Proposal for amendments to the proposal for the 04 series of amendments to UN Regulation No. 26 (External projection for passenger cars – document GRSG/2019/34)

Submitted by the experts from France and OICA *

The text reproduced below was prepared by the experts from France and OICA to clarify requirements in UN Regulation No. 26 on windscreen wipers. It is based on document ECE/TRANS/WP.29/GRSG/2019/34 submitted by France. The modifications to the document GRSG/2019/34 are marked in **red** characters.

Figure 0 - Example of parts distribution

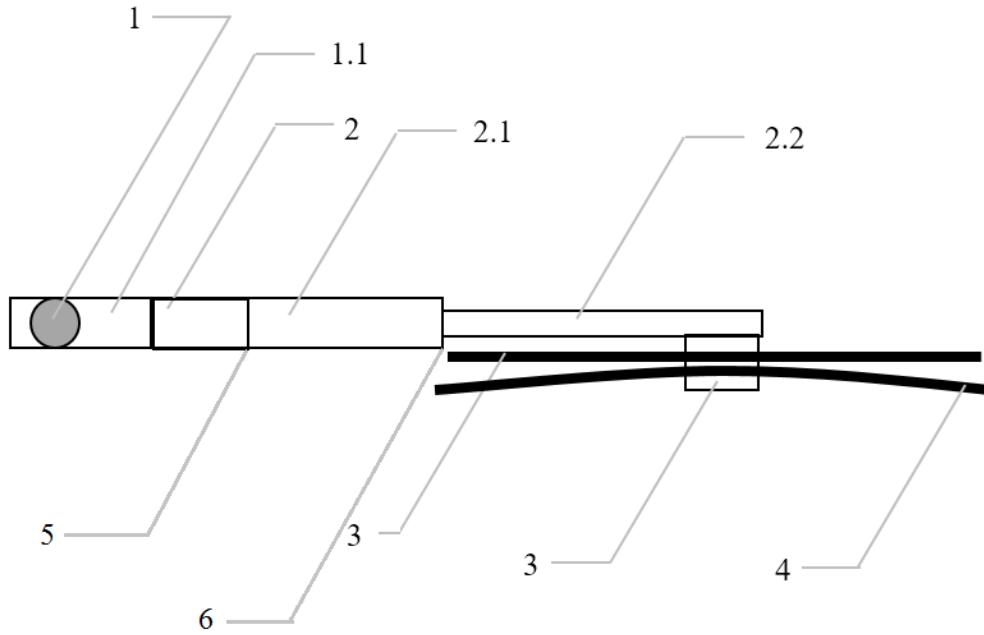
- "6.4. Windscreen wipers
- 6.4.1. The windscreen wiper fittings shall be such that the wiper shaft (**number 1 in Figure 0**) is furnished with a protective casing (**number 1.1 in Figure 0**) which has a radius of curvature meeting the requirements of paragraph 5.4. above and an end surface area of not less than 150 mm². **The holder (head and main part, i.e. numbers 2, 2.1 in Figure 0) are designed with a radius of curvature meeting the requirements of paragraph 5.4. above.** In the case of rounded covers, these shall have a minimum projected area of 150 mm² when measured not more than 6.5 mm from the point projecting furthest. These requirements shall also be met by rear window wipers and headlamp wipers.

- 6.4.2. Paragraph 5.4. shall not apply to the wiper blades (**number 4 in Figure 0**), ~~or~~ to ~~any~~ supporting members (**number 3 in Figure 0**) if present, to second holder (**number 2.2 in Figure 0**) if present, to the functional hinge between the holder head and the holder (**number 5 in Figure 0**) if present, or to the junction between the main and the second holder (**number 6 in Figure 0**) if present. However, these units shall be so made as to have no sharp angles or pointed or cutting parts.

- 6.4.3 Compliance with the provisions in paragraphs 6.4.1 and 6.4.2 shall be verified with the wipers in parked position.**
-
